Anonymous Referee #2

Liu et al. describe a method to estimate CO₂ emissions from power plants using satellite observations of tropospheric NO₂ columns. The method involves the estimation of NO_x emissions using a top-down approach previously developed by the authors and estimation of CO₂ emissions by applying a NO_x/CO₂ emission ratio derived from direct stack emission measurements of both gases. The topic of the manuscript is important and relevant in the context of the ongoing development of the global emission monitoring system intended to support the elaboration of climate control and mitigation strategies. Although the idea to use satellite NO₂ measurements to constrain CO₂ emissions from fossil fuel burning is not new, application of this approach to specifically power plant emissions is a step forward. Another new point of the study is the analysis of the relationship between NO_x and CO₂ emissions from different types of coal-fired power plants in the US. That said, I keep wondering whether and how the method proposed in this manuscript can be proven useful in any scientific or practical applications. The weak points of the manuscript and my suggestions to the authors are

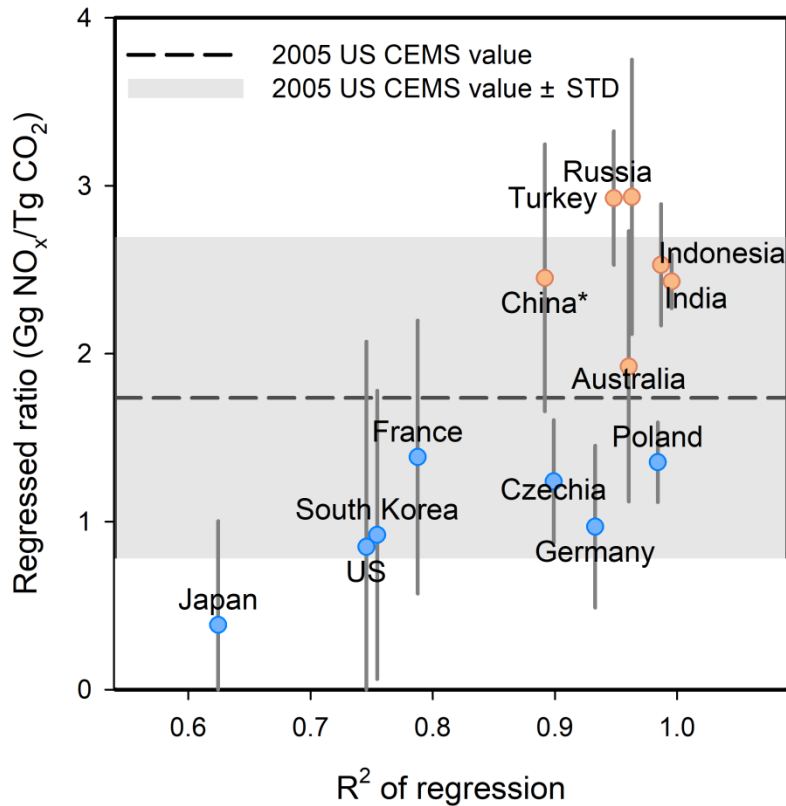
I find that the manuscript lacks clear logic in presenting the ideas and results of the authors. Specifically, while the main focus in Section 2 (“Method”) is given to the analysis of the CEMS stack measurements in the US in the period from 2005 to 2017, it is not explained and justified how the outcome of this analysis can be used for applications outside of the US. Such possible applications are illustrated in the manuscript (in Sect. 3.3) by the example of only one power plant (Matimba), for which the authors use the NO_x/CO₂ emission ratio estimated only for 2005 and even argue that this estimate (based on the US data) is not directly applicable to the Matimba plant. Furthermore, if the “regressed” estimates of the NO_x/CO₂ emission ratio are not directly applicable to power plants outside of the US, the application of these approximate estimates to the selected 8 power plants inside of the US (presumably to test the method) seems to be pointless, as the CEMS measurements provide accurate direct estimates of the NO_x/CO₂ emission ratio for any power plant in the US. As for the Matimba power plant, a reasonable alternative to using the CEMS measurements would be to get a corresponding estimate of the NO_x/CO₂ emission ratio from the ODIAC inventory. Therefore, in the present form, the discussion and evaluation of the method is very confusing and, to some extent, misleading. In this respect, I recommend that the authors illustrate the potential of their method and the usefulness of the analysis of the US CEMS data by considering a few more power plants outside of the US (e.g., in China), paying special attention to the accuracy of the estimates of the NO_x/CO₂ emission ratio based on the US CEMS data versus the accuracy of corresponding estimates that can be obtained directly from available data of global and regional emission inventories.

As suggested, we added the comparison of the ratios derived in this study with those in the global coal-fired power plant emissions database (GPED) in Section 3.3.1. GPED is the only publicly available bottom-up emission database reporting both NO_x and CO₂ emissions for individual power plants all over the world. The US values show reasonable agreement with other countries' values identified by GPED. The details are as follows:

“Figure 8 shows the NO_x to CO₂ emission ratios for 2010 from the global power emissions database (GPED; Tong et al., 2018), which is the only publicly-available bottom-up emission database that reports both NO_x and CO₂ emissions for individual power plants for every country. All countries with over 30 coal-fired power plants in GPED are shown in Figure 8. Not surprisingly, countries with more strict standards in place for NO_x emissions from power plants (i.e., NO_x emission limit value (ELV) < 200 mg/m³; hereafter referred to as “more strict countries”) have smaller NO_x to CO₂ ratios (i.e., 1.0 versus 2.5 on average) than countries with less strict standard (i.e., NO_x ELV > 200 mg/m³; hereafter referred to as “less strict countries”). Additionally, the correlation coefficients are smaller for more strict countries (i.e., 0.82 on average) as compared to less strict countries (i.e., 0.96 on average), because power plants in more strict countries are more likely to have installed post-combustion NO_x control systems, which likely lowered $ratio_y^{CEMS}$, similar to what occurred in the US over our analysis period (Section 2.2.2).

We further compare the 2005 US $ratio_{regressed}^{CEMS}$ in Table 1 with the GPED NO_x to CO₂ emission ratios for less strict countries. We chose the 2005 value for comparison based on the following considerations. In 2005, the US EPA issued the Clean Air Interstate Rule (CAIR) to address the interstate transport of ozone and fine particulate matter pollution for eastern US states, which reduced NO_x emissions and, thus, NO_x to CO₂ ratios ($ratio_y^{CEMS}$). However, similar comprehensive control strategies have not been adopted

in less strict countries. In this way, the 2005 values are expected to show better consistency with the NO_x to CO₂ ratios of less strict countries than values for more recent years. Note that the GPED database does not give information on ratios by coal type. Therefore, we use $ratio_{regressed}^{CEMS}$ for bituminous coal, which is the most widely used coal type in coal-fired power plants in most countries.

The ratios for individual power plants in less strict countries tend to be larger than the US $ratio_{regressed}^{CEMS}$ for 2005, considering that power plants in those countries may not be equipped with any NO_x control devices or even low-NO_x burners, a technology which is widely installed in US power plants with and without post-combustion NO_x control devices. Most ratios range from US 2005 $ratio_{regressed}^{CEMS}$ to 2005 $ratio_{regressed}^{CEMS}$ + standard deviation (Figure 8). It is no surprise that some less strict countries have ratios higher than this range, which also occurs for some US power plants without post-combustion emission controls (Figure 4). However, there are considerable uncertainties in the GPED database given the scarcity of reliable emissions information in less strict countries. For example, the GPED NO_x and CO₂ emissions estimates for Turkey and Russia, which are outliers in Figure 8, are subject to more assumptions and, thus, larger uncertainties than countries with high-quality country-specific emission data, such as China, which has a high-resolution emissions database (CPED; Liu et al., 2015), and India, which has a database developed by Argonne National Laboratory (Lu et al., 2011).

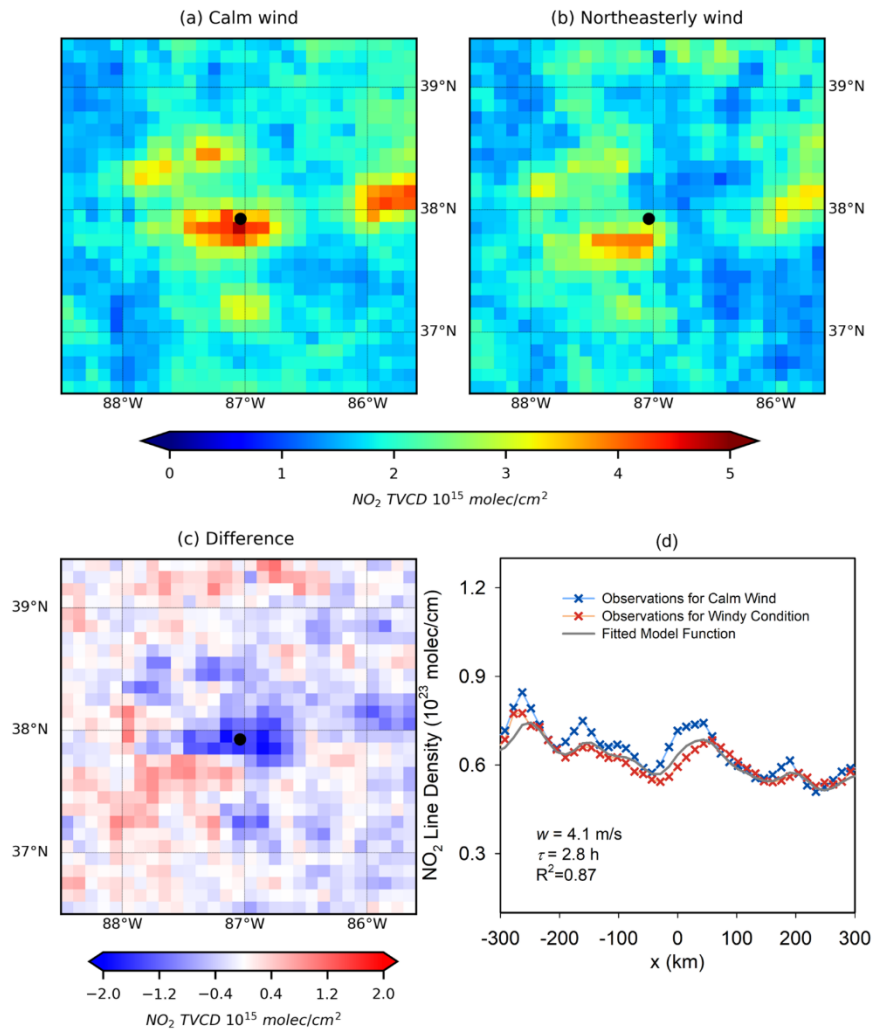
p.4, l.3-33: I suggest the authors provide an additional figure illustrating the NO₂ plume from the Rockport power plant along with a corresponding Gaussian fit.

Response: Thanks. We have added it as Figure 2 in the revised manuscript.
